From: Pardee, Michael <mpardee@Sciame.com>
Sent: Friday, May 03, 2019 12:35 PM
To: James Dearth; Murphy, Ryan; Giusti, Adam; Asante, Joseph; Buhler, Jacklyn
Cc: Steven Grzic; Phil Carvelas; Porcelli, Michael
Subject: RE: CUNY - PCO#098 - WT-3 Clerestory Remediation
Attachments: CUNY_Design Movement Between Aud and Main Bld_Submittal
084426-07-01.pdf

PROJECT: CUNY New Academic Building DATE SENT: 1/23/2017
CUN-901
RETURN BY: 1/30/2017
SUBJECT: 1130 - Design Movement between the Auditorium and Main Building RFI ID: 1130
TYPE: RFI TRANSMITTAL ID: 13818
PURPOSE: To Answer VIA: Info Exchange

ASK-266:
WT-3 HEAD ANCHOR
DETAIL: RFI 1130
04/27/17

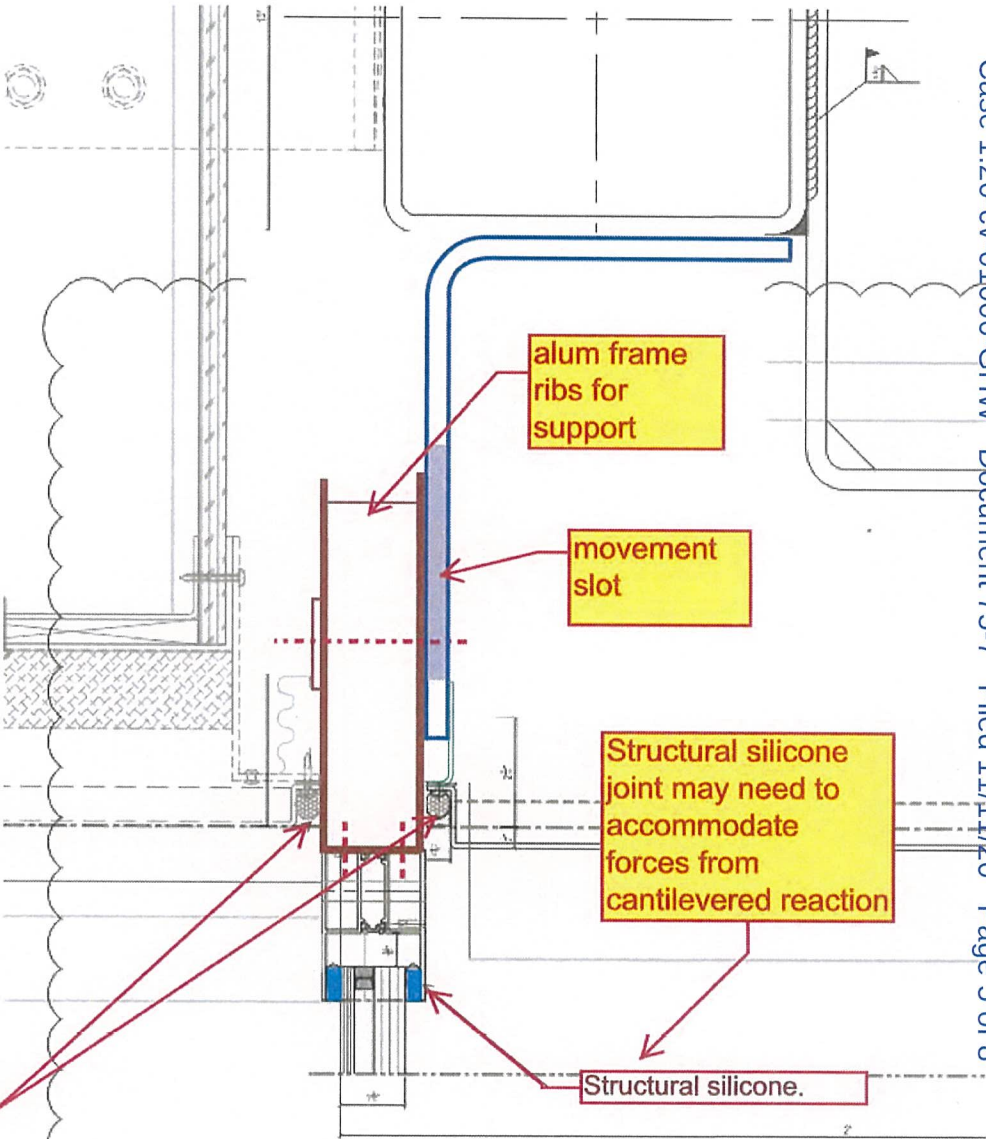
QUESTION: In reviewing submittal 084426-007-01 the Design Team included a comment that "The structural adequacy of this anchor and the relative movements between auditorium roof and main building still has not been submitted." Please define what the relative movement between the auditorium roof and main building is per design so that Whitestone can provide Yuanda with that information for analysis to ensure that the design movement was adequately addressed in the facade design.

The glass must transition from sitting at some location. Where this happens on elevation add required details. Note, we want this to happen at a column line. There will be little vertical movement.

1. SHOP DWG SUBMISSION NUMBERS MUST BE IN SEQUENCE OF THE PREVIOUS SUBMISSIONS
2. THE CONCERN WAS PREVIOUSLY NOTED IN 2014 UNDER SUBMITTALS 084413-020-01 AND 084413-020-02 ON SHEETS D328, D329, D331 AND Y52 TO VERIFY A LARGER MOVEMENT JOINT TO ACCOMMODATE ROOF DEFLECTIONS. THE NOTE WAS ALSO INDICATED ON RFIS 1033 AND 1033R1.
3. REFER TO ATTACHED ESTIMATED ROOF DEFLECTIONS BY WSP. NOTE: WSP CLARIFIED 50% OF THE SDL HAS ALREADY OCCURRED AND THAT FIGURE CAN BE REDUCED. EVEN WITH THE 50% REDUCTION OF THE SDL DEFLECTION, WE BELIEVE THE CONTRACTOR'S HEAD ANCHOR DETAIL MAY NOT ACCOMMODATE THE ESTIMATED ROOF DEFLECTIONS
4. REFER TO ASK- 266 FOR SUGGESTION FOR THE HEAD ANCHOR DETAIL TO ACCOMMODATE POTENTIAL MOVEMENT

HEAD ANCHOR UP POSITION:

HEAD ANCHOR DOWN POSITION:
